- 3. Folz Subdivision 2023 Replat; KPB File 2023-085R1
McLane Consulting Group / ZPA, LLC
Location: Seward Highway
Bear Creek Area**

**ITEM #3 - PRELIMINARY PLAT
FOLZ SUBDIVISION 2023 REPLAT**

KPB File No.	2023-085R1
Plat Committee Meeting:	April 8, 2024
Applicant / Owner:	ZPA LLC / ANCHORAGE, AK
Surveyor:	James Hall / McLane Consulting Inc.
General Location:	Bear Creek Area

STAFF REPORT

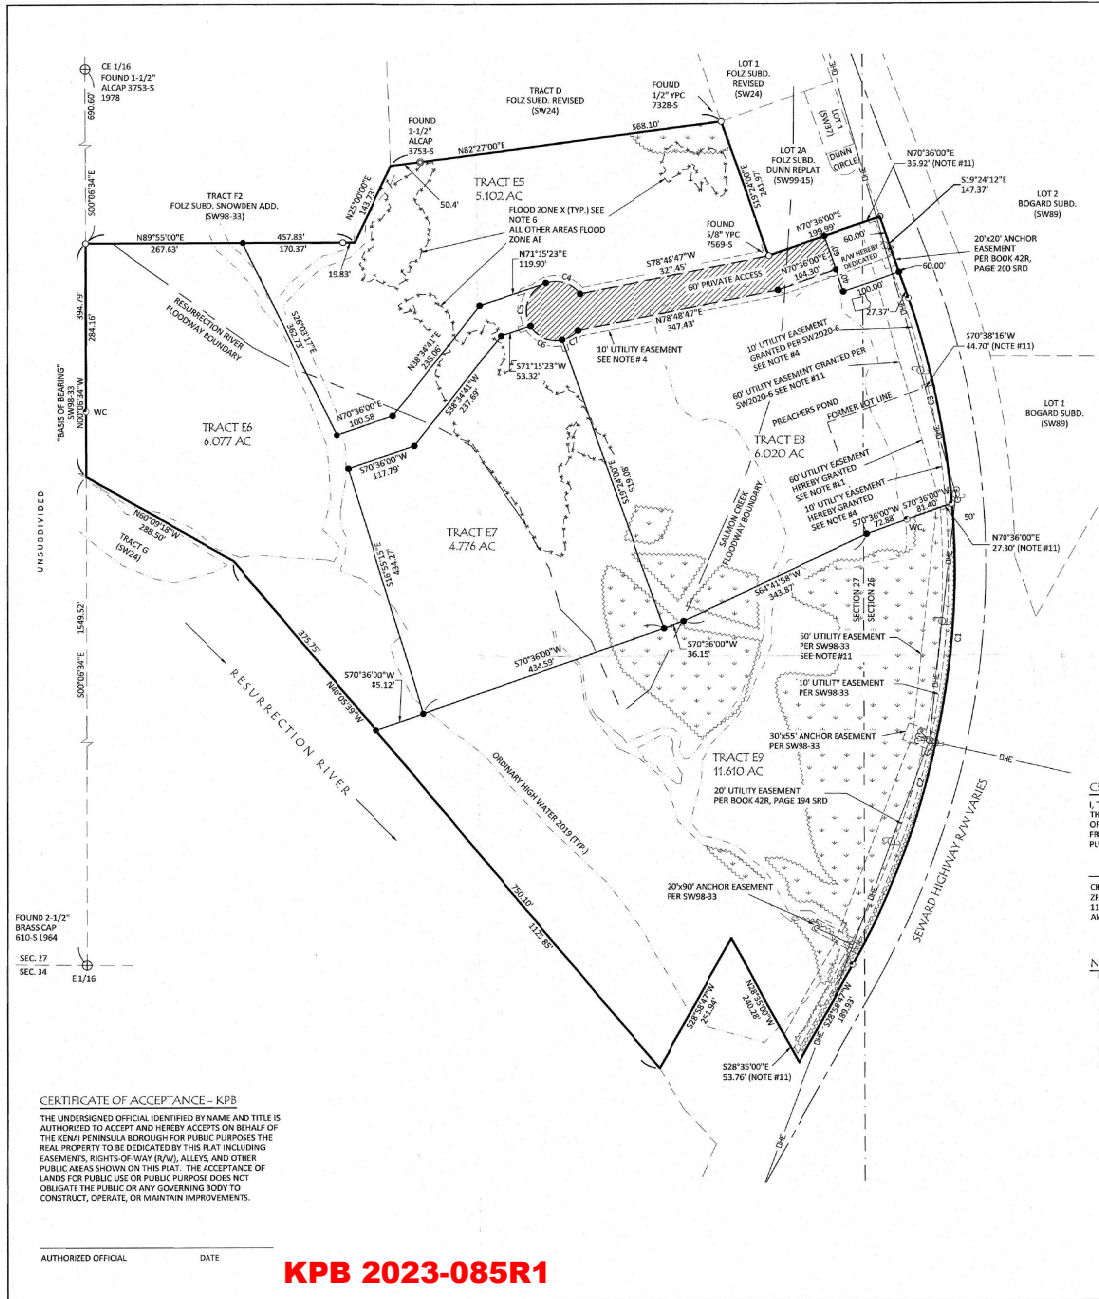
The plat is proposing a private cul-de-sac with a public turn around at the entrance to be dedicated to the Borough. This is a requirement of 20.80.020.C as part of Chapter 20.80 Private Streets and Gated Communities. The three notes of 20.80.020.F are listed at 13, 14 and 15. A Certificate of Acceptance with dedication to the Borough for the turnaround needs to be added to the final.

The plat is affected by a section line easement running north / south through the property. A portion was vacated by KPB Resolution 2017-13 but the part lying north in Tract B & C was not vacated. **Staff recommends:** the surveyor verify if the section line easement still exist and if so, show on the plat.

- Line type for the flood zone looks to be a fence line, staff recommends to use a different type line and show it in the legend.
- Label the witness corners that are not labeled as WC.

- Tie the subdivision to the nearest BLM / GLO Corner.

- Staff recommendation:**
Need to change the KPB File number to 2023-085R1
Address of owner per Assessing information only has 1120 Huffman Rd, Anchorage, please verify address.

- Staff recommendation:**
- On Folz Subdivision, Snowden Addition SW98-33 in the ROW of Seward highway at Tract E1 and Tract C there appears to be a jog in the right-of-way of 4 feet, please verify. State of Alaska Right-of-way map Project No ERFO-5(1) looks to show a jog also.

- The section line easement running north/south was vacated by Resolution 2017-13 south of Tract C, need to show easement running north.
- E. All parcels of land including those intended for private ownership and those to be dedicated for public use or reserved in the deeds for the use of all property owners in the proposed subdivision, together with the purposes, conditions, or limitations of reservations that could affect the subdivision;

- Staff recommendation:**
Need to get with Addressing to get a name for the private road. Name should have been obtained prior to submittal, to be approved by Plat Committee.

- Staff recommendation:**
Tract H to the west needs labeled and a line between Tract G & H added
- N. Apparent encroachments, with a statement indicating how the encroachments will be resolved prior to final plat approval;

- Staff recommendation:**
There appears to be encroachments along the northwest line, verify and report to staff.

Need to add a Certificate of Acceptance to the Borough for the turn around

Need overall data on lines

Show a distance across the straight portion of the flag lot for reference.

Show measured and recorded data.

Need to add a Certificate of Acceptance to the Borough for the turn around

Add the date of April 8, 2024 to the Plat Approval

Verify the address of the members signing.
